# **Supplementary Report**

**Development Assessment**

**Subject:** Development Application 2021/1487, 35 Bungan Head Road,

Newport 2106

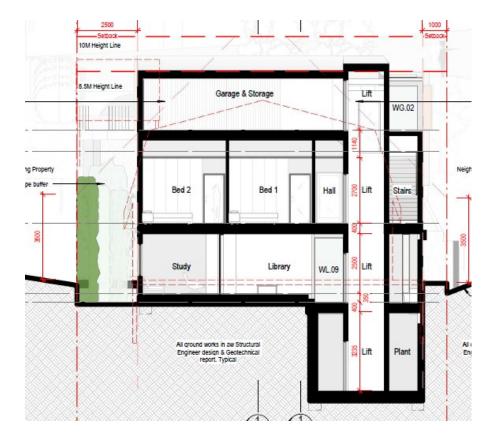
• The southern (rear) portion of the garage has a reduced roof height from RL54.71 to RL54.41. The below sectional drawing by the project architect shows the reduced roof height and noted that the previous outer roof edge ran at the same level at the top of the lift-shaft.

- The footprint, location and layout of the garage has not changed.
- The applicant contends that no unreasonable view loss occurs consequent of the garage.

The applicant contends that by reducing the height at the southern portion of the garage, this results in the garage being compliant with the 8.5m height plane, and further contends that the 300mm reduction in height corresponds to a 300mm increase in the provision of views retained from the neighbouring property.
